institution:	University of Hawaii at Manoa High Energy Physics Lab Instrumentation Development Lab
title:	althea
revision:	A'
IDLAB design #:	IDL_18_040
circuit design:	mza
PCB design:	mza
sheet #:	1 of 1
sheet description:	FPGA
date last modified:	2019-08-28

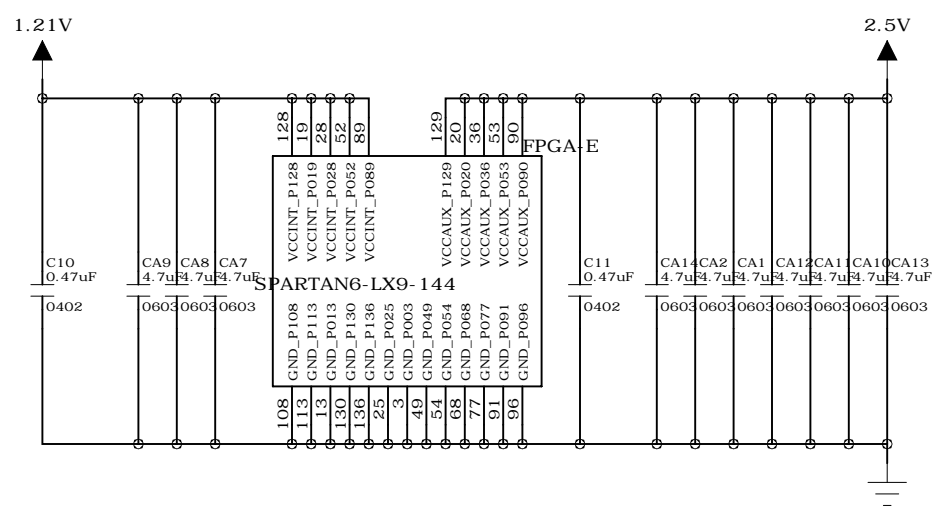
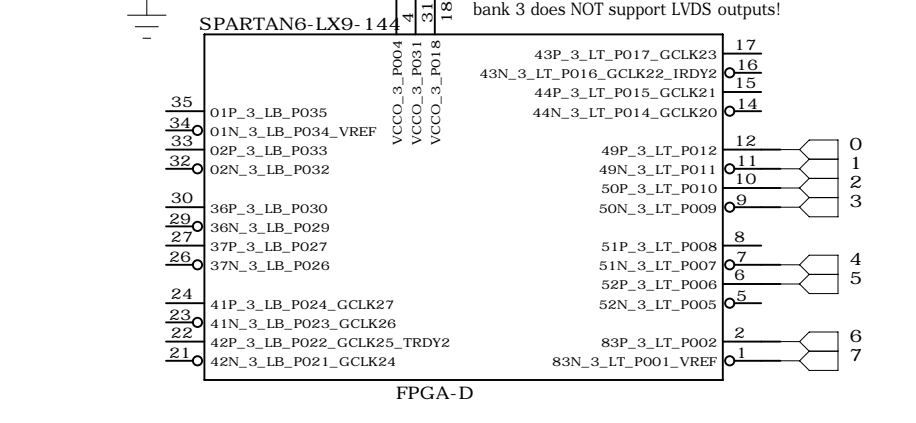
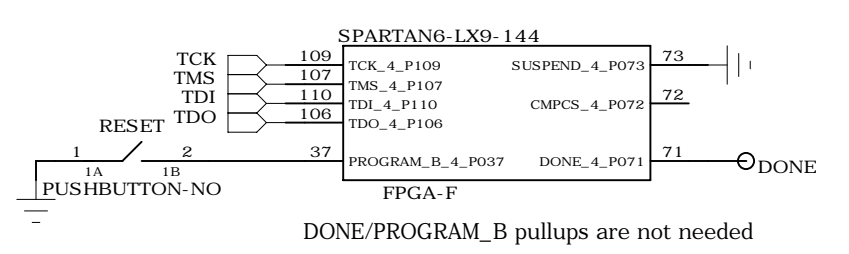
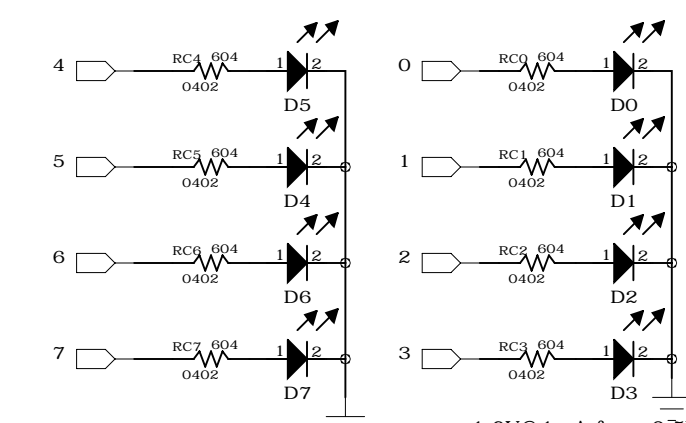
2019-08-28 notes for revB:
 1008 22uF caps don't exist, so change to 0805/10uF or 1206/22uF
 power connector is wired backwards compared to other boards that use the same connector
 spi flash doesn't support x4 mode, so it might be better to find an alternate part that has more bits
 spi flash is miswired (mosi and miso are reversed)
